OH-58...

Get Some Wingtips

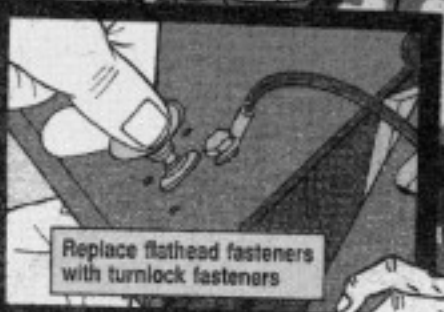
On our Kiowas that have been modified by MWO 55-1520-228-50/25, the fasteners for the tail rotor driveshaft covers are a real pain.

You have to use a flat-tip screwdriver and a lot of force to turn the fasteners.

If the screwdriver slips when you apply pressure, you could easily damage the cover—maybe even put a hole in it—and injure your hand.

When screwdriver slips, cover gets damaged

REPLACE THOSE FLATHEAD FASTENERS WITH STUD ASSEMBLY TURNLOCK FASTENERS, NSN 5325-00-839-2517. IT HAS A WING TIP THAT'S MUCH EASIER TO PUSH AND TURN. IT'S A LOT SAFER, TOO.

Replace flathead fasteners with turnlock fasteners
